REGIONAL REVIEW FINDING

ARC REVIEW CODE: R9072001

Name of Proposal: TreatMed Biomedical Waste Treatment Facility

TREATMED BIOMEDICAL WASTE TREATMENT FACILITY DRI
City of Fairburn
Environmental Planning Division Review Comments

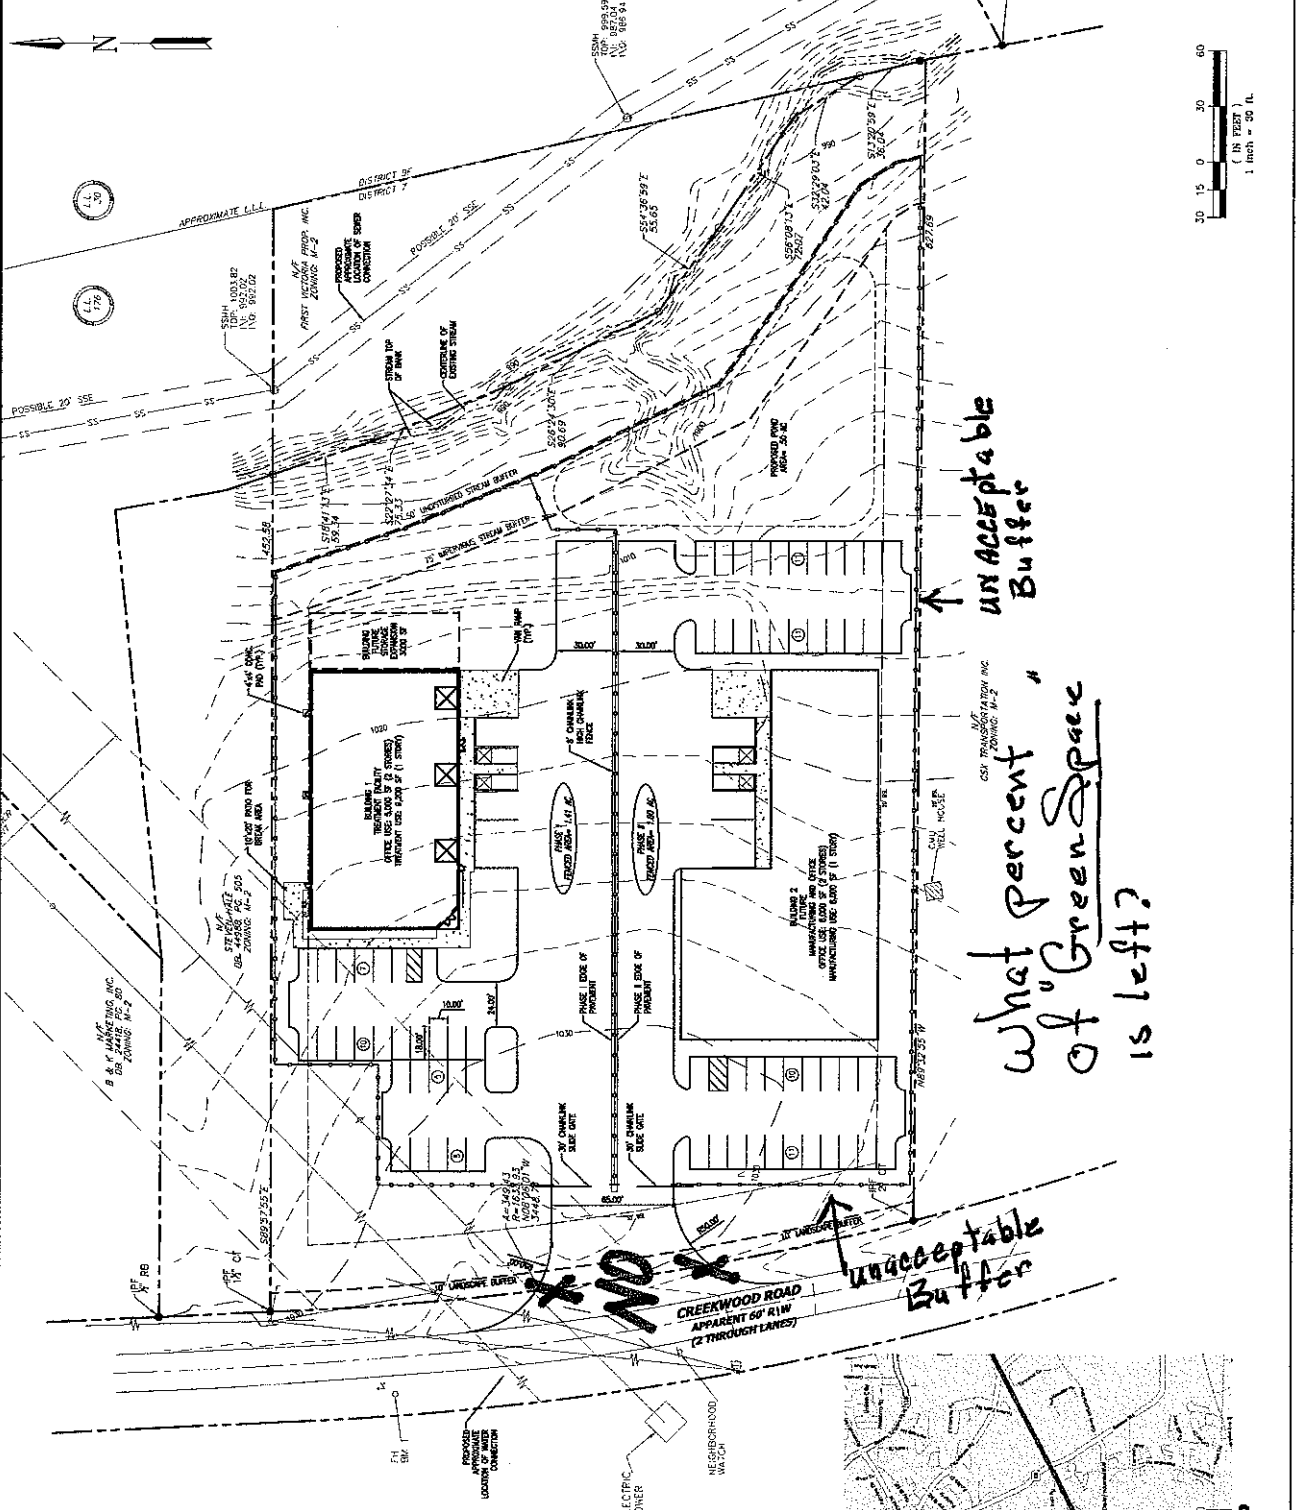
I have taken the liberty of marking the site plan map, ARC has provided with the Regional Review Notice, to demonstrate some very important issues.

Most importantly, this proposed facility is less than 1350 feet from our property line and they would contaminate our drinking water. We are on a well.

Please deny this proposal.

LAND DISTURBANCE PLANS FOR TREAT MED BIOMEDICAL WASTE TREATMENT FACILITY
LOCATED IN LAND LOTS 1062, 202, AND DISTRICT 1ST SECTION CITY OF FAIRBURN, GEORGIA
SITE PLAN

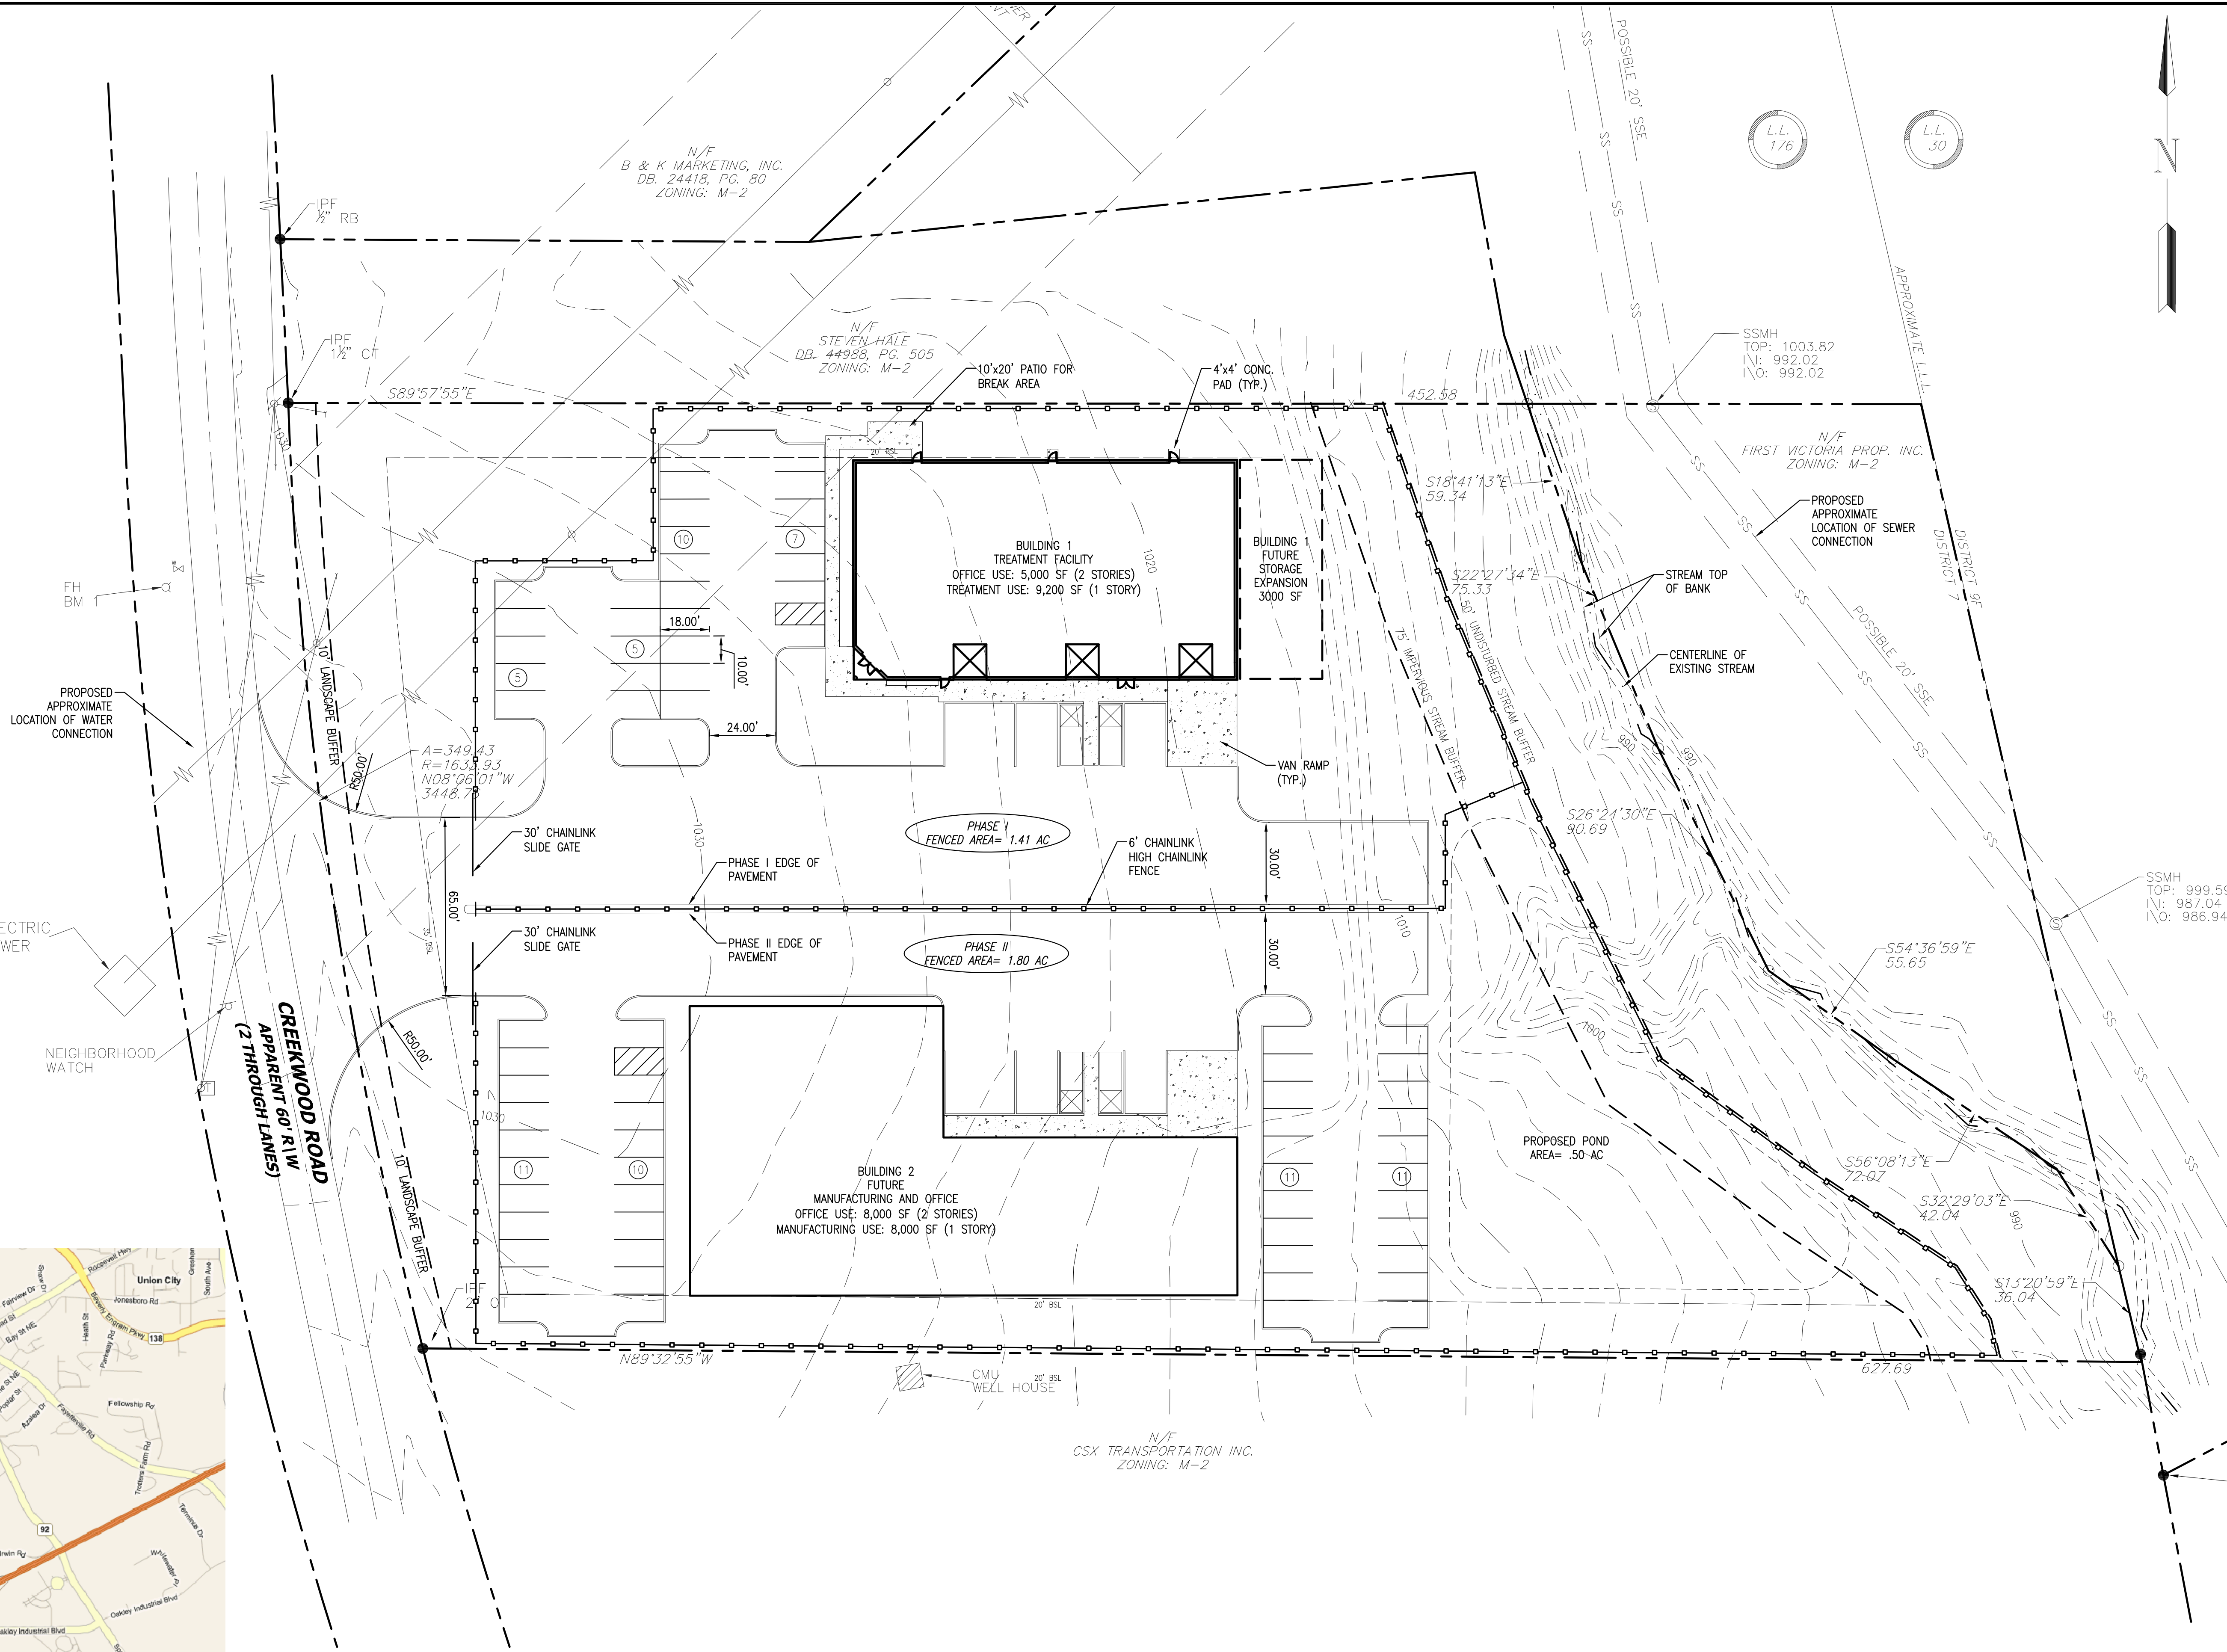
There are no perennial (blue-line) streams on the property, based on the USGS coverage for the area and no water supply watershed buffers are required. The site plan shows a 75-foot stream buffer on the property, which is consistent with the District Model Stream Buffer ordinance and is presumably consistent with the City of Fairburn stream buffer ordinance. Additionally, all state waters on the property will also be subject to the Georgia Department of Natural Resources (DNR) 25-foot erosion and sedimentation control buffer.
